*Kingston
Ash Disposal*

KINGSTON STEAM PLANT - RAISING OF ASH DISPOSAL AREA DIKES - INSTALLATION OF NEW SPILLWAYS - FOUNDATION IMPROVEMENT

KINGSTON STEAM PLANT - ANNUAL ASH DISPOSAL AREA INSPECTION

KINGSTON STEAM PLANT - ANNUAL ASH DISPOSAL AREA INSPECTION

PLAN-RAISING ASH DISPOSAL AREA DIKE

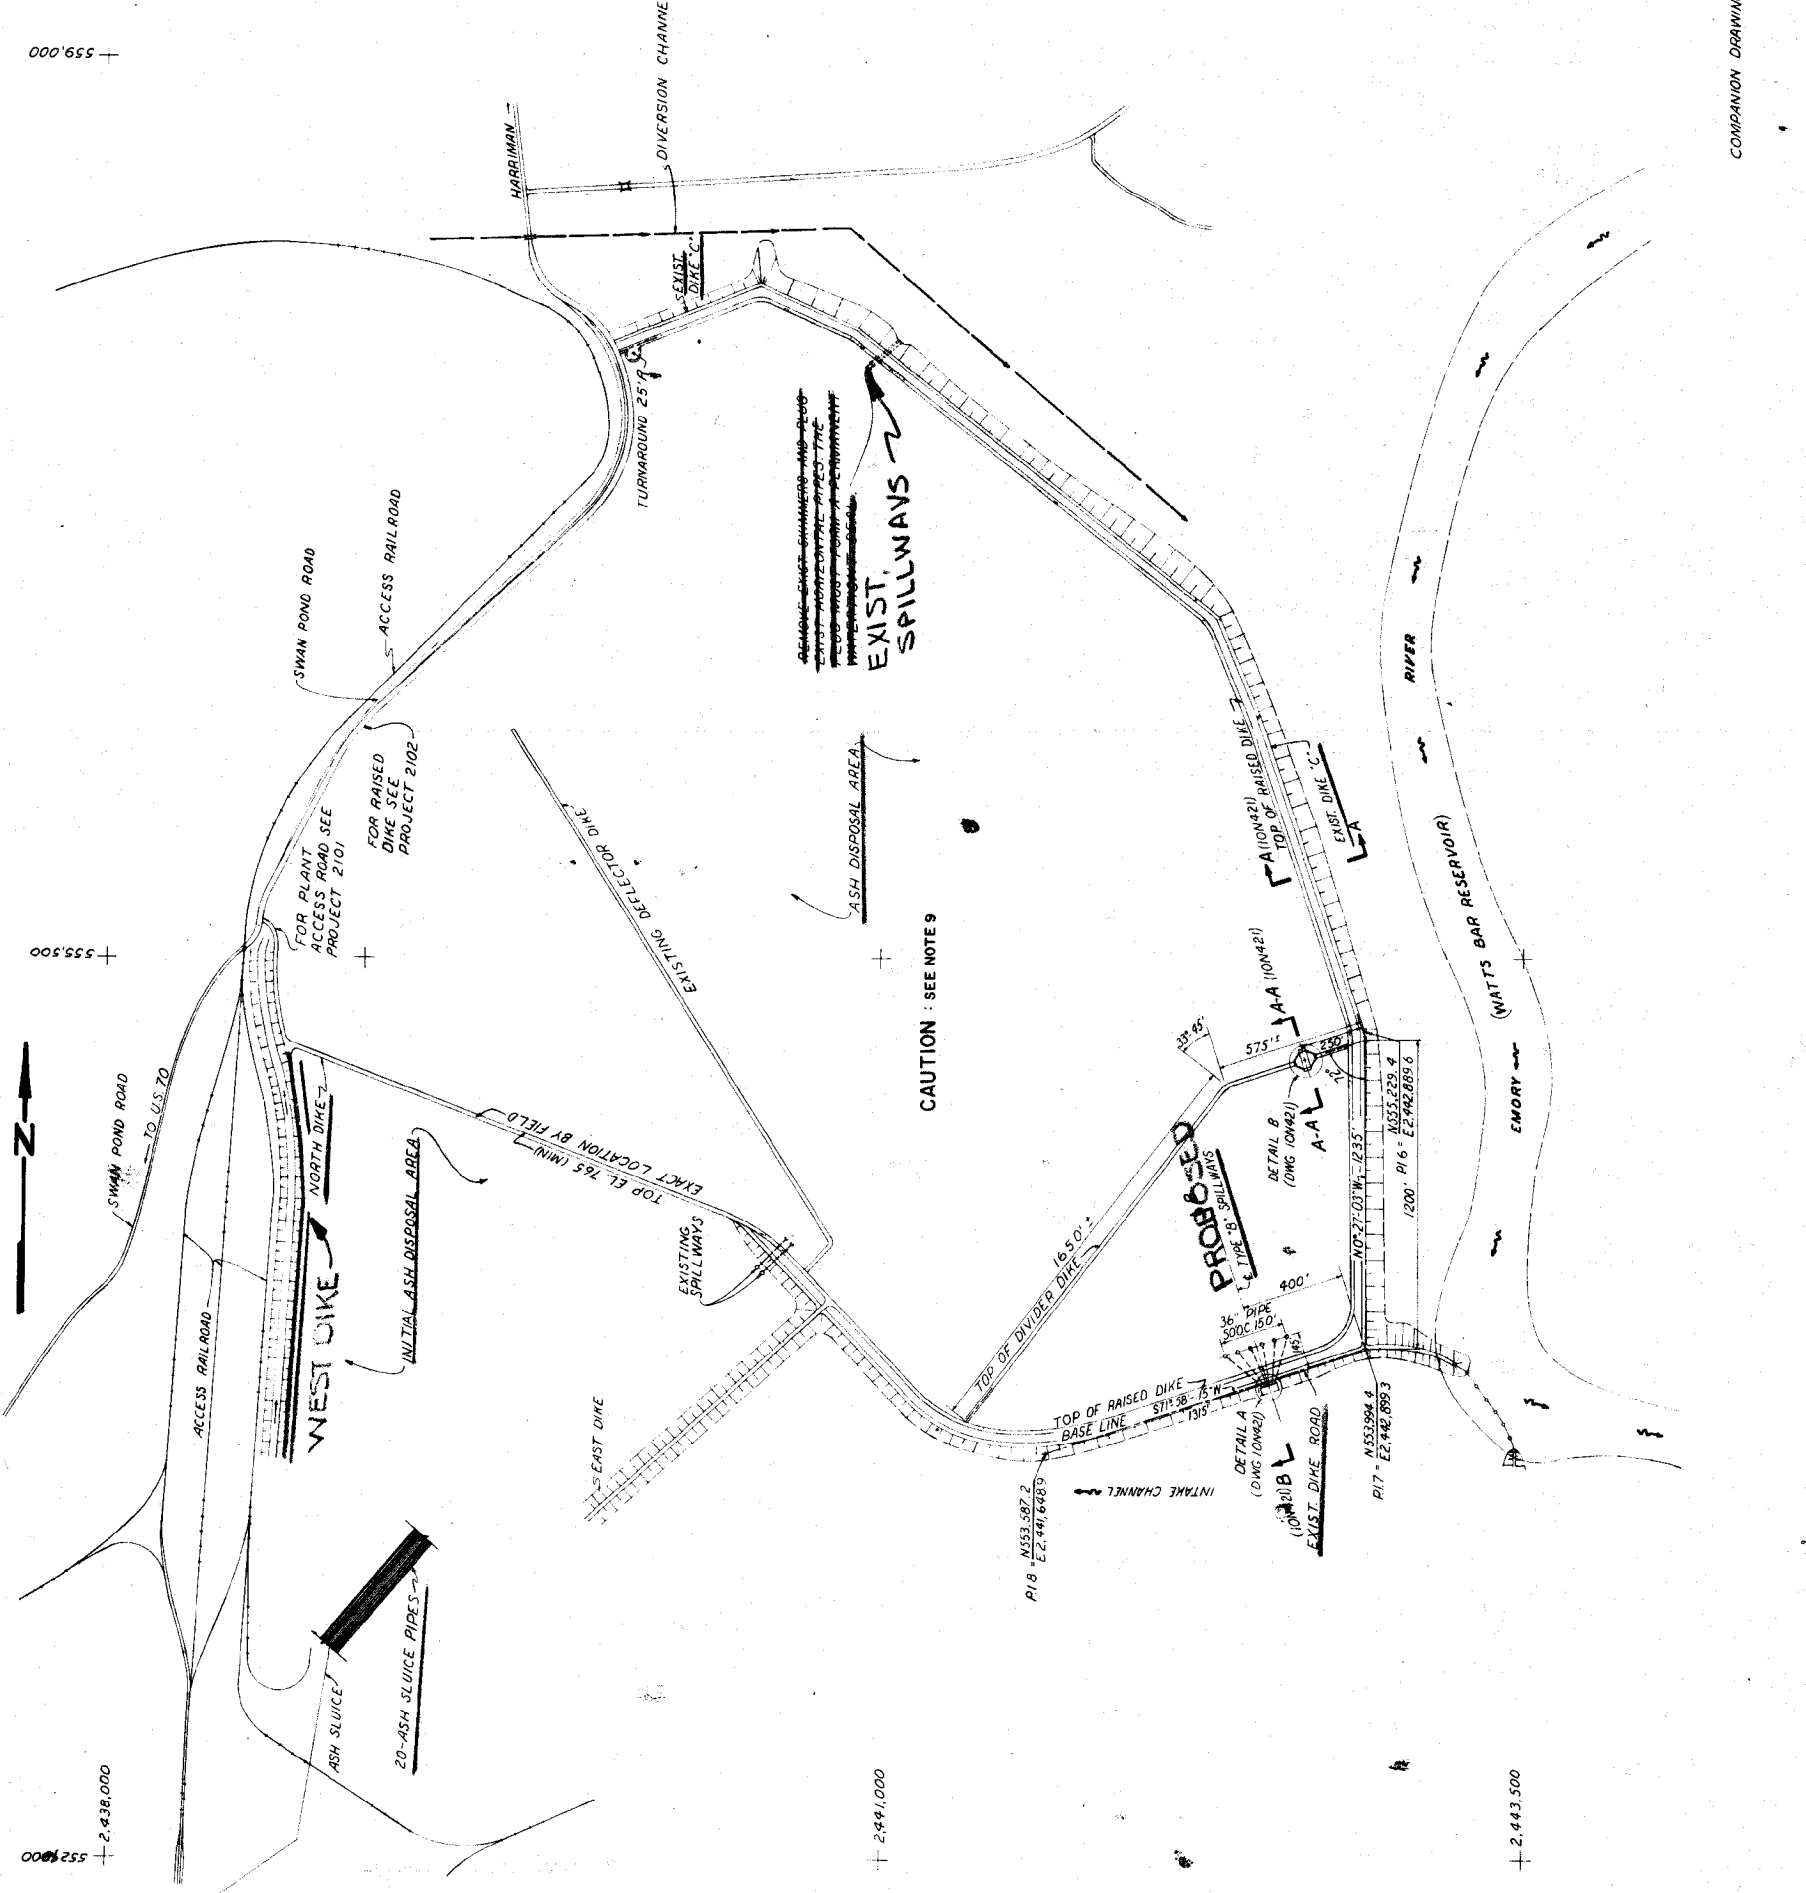
On the attached print of drawing 10N420, the different areas are designated.

At the time of this inspection, CSB was in the process of raising the dikes and installing new spillways in accordance with EN DES drawings and specifications.

The outside slopes of dike C, east dike, and the road dike have an excellent cover of vegetation except in the areas where construction has removed the vegetation. The original dikes are in good condition with no visible signs of instability.

Visual inspection of the spillways and skimmers in the ash disposal area showed them to be in good condition and operating properly.

The outlets of the spillway pipes from the ash disposal area were submerged by Watts Bar Lake and could not be inspected. Visual inspection of the area around the outlets showed no evidence of loss of ash into Watts Bar Lake at this time.

We have no recommendations for corrective work as a result of this inspection.

We recommend that EN DES be notified as soon as CSB has finished raising the dikes and another inspection be made at that time.
